PLUTO-KUIPER BELT MISSION Written Questions and Answers

Last updated 3/16/01

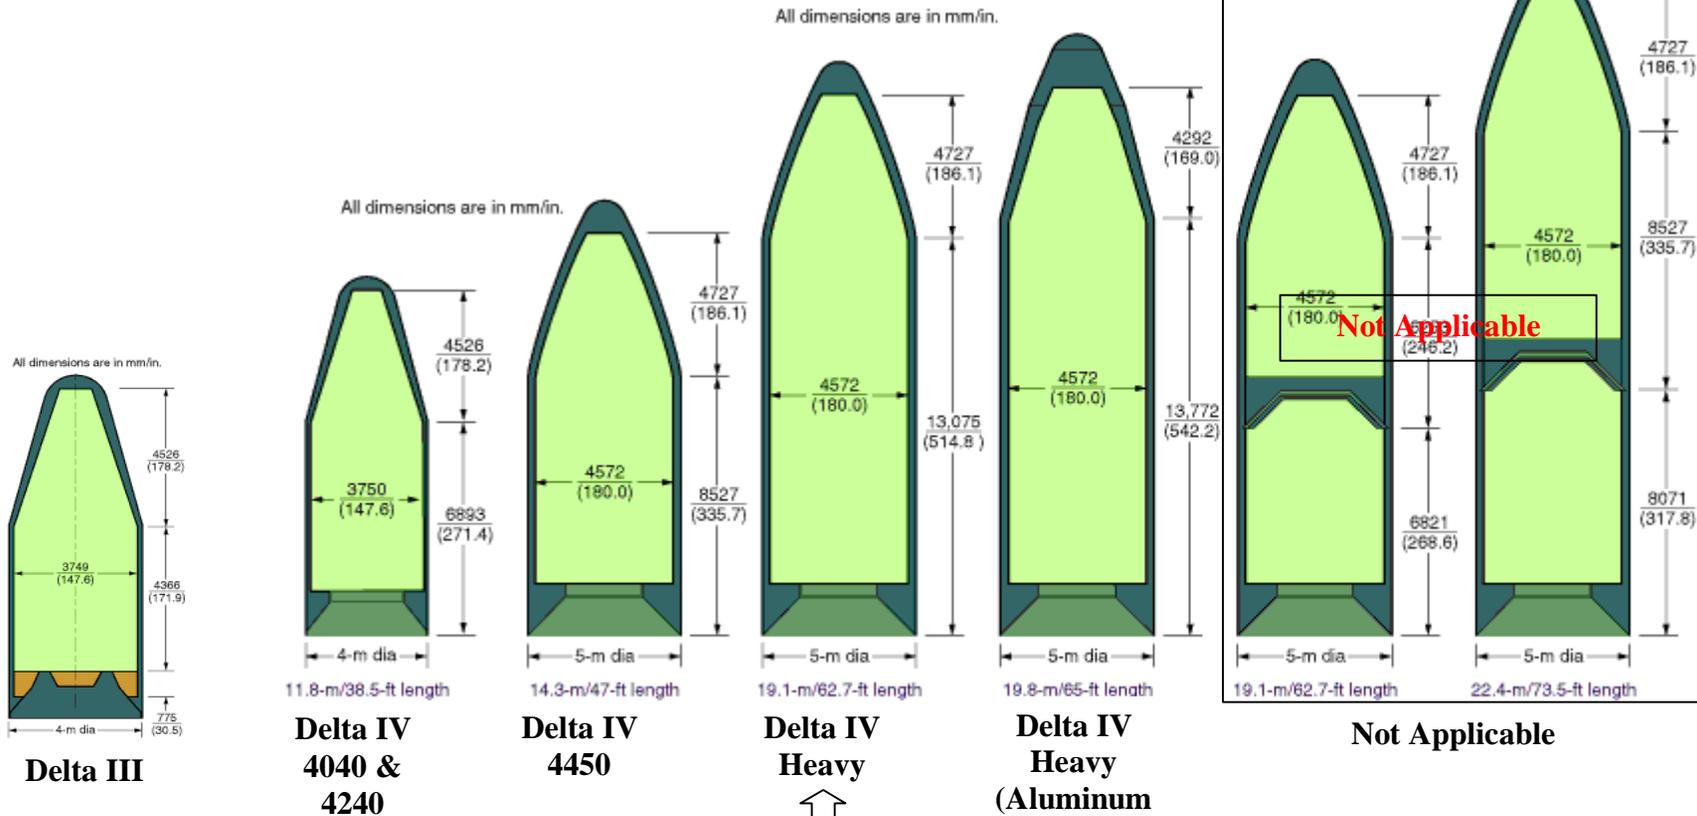
8. What is the possibility and the C3 performance at 127 and 144 km²/sec² of a DELTA 4440 and an ATLAS V 411?

Response: While KSC and the NRO have performed studies with both Boeing and Lockheed Martin regarding these ELV configurations, they are not offered for use on this AO. The primary reason is cost. These configurations are not standard, commercially available configurations; therefore, in order to qualify these configurations for flight, it would require significant non-recurring engineering and analysis by the Launch Service Provider at cost to this mission.

Delta IV Payload Fairings

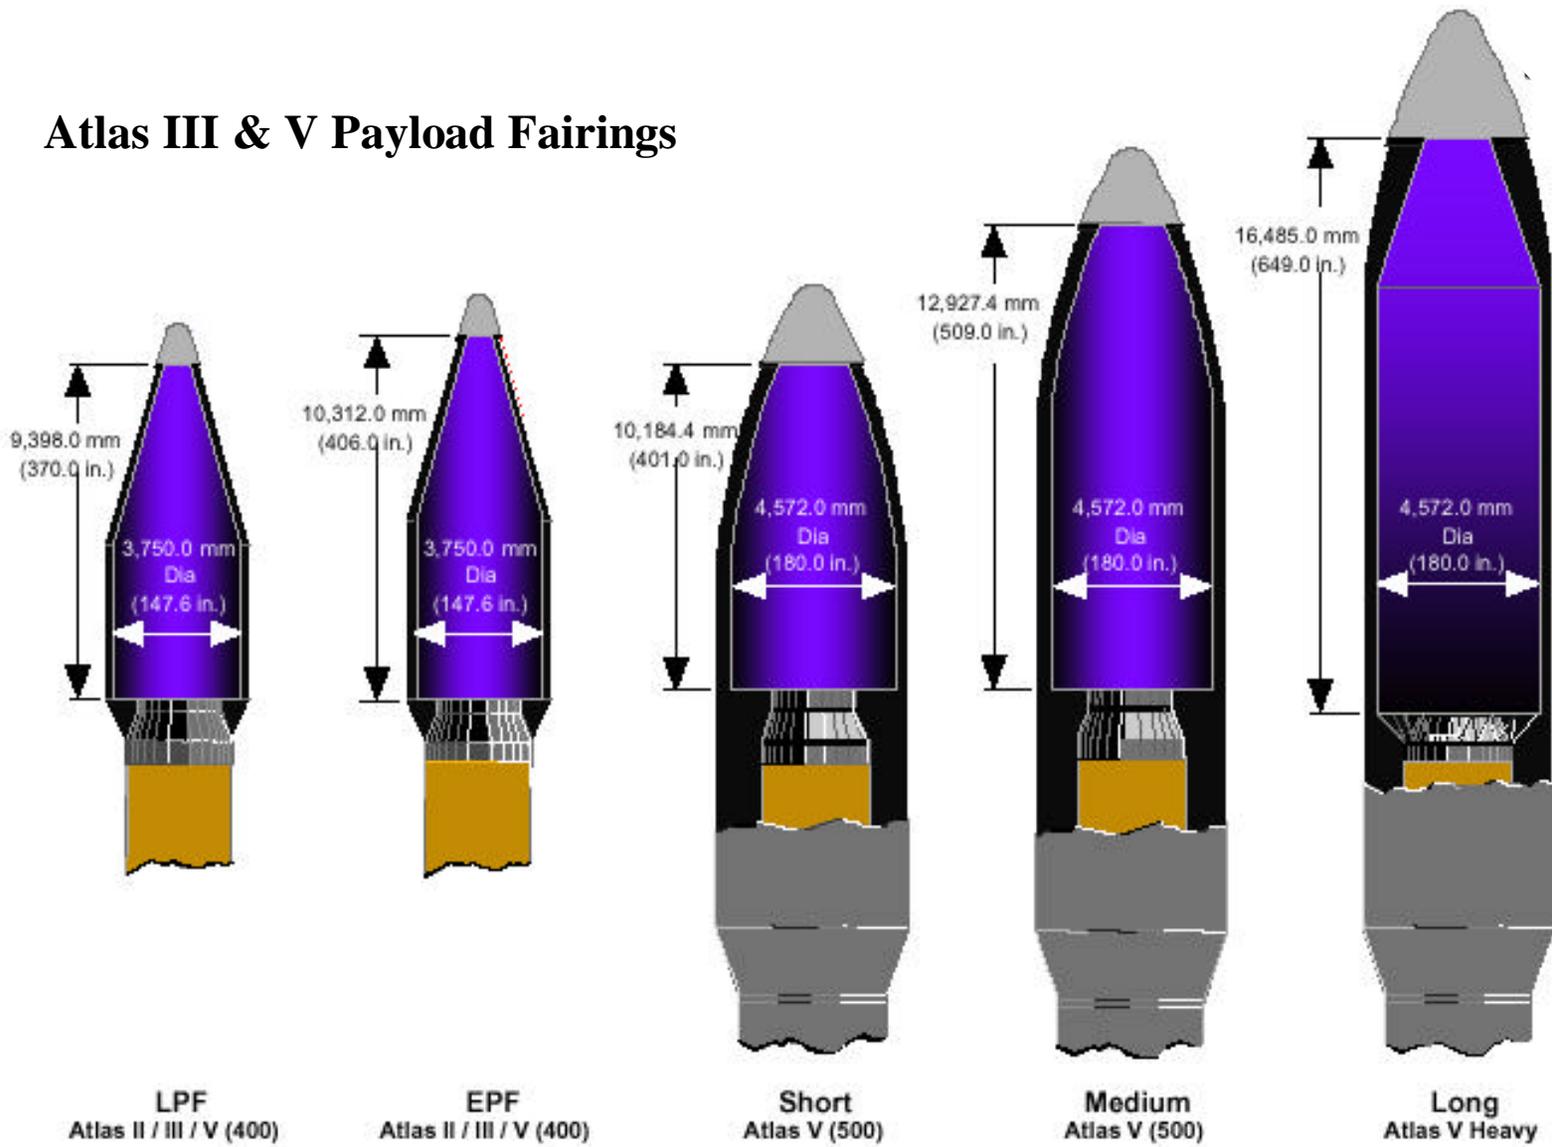
9. What are the latest/official internal fairing dimensions for the 4m and 5m ATLAS IIB & V and DELTA III & IV?

Response: See attached figures below

↑
The D-IV Heavy performance figures are based on this config
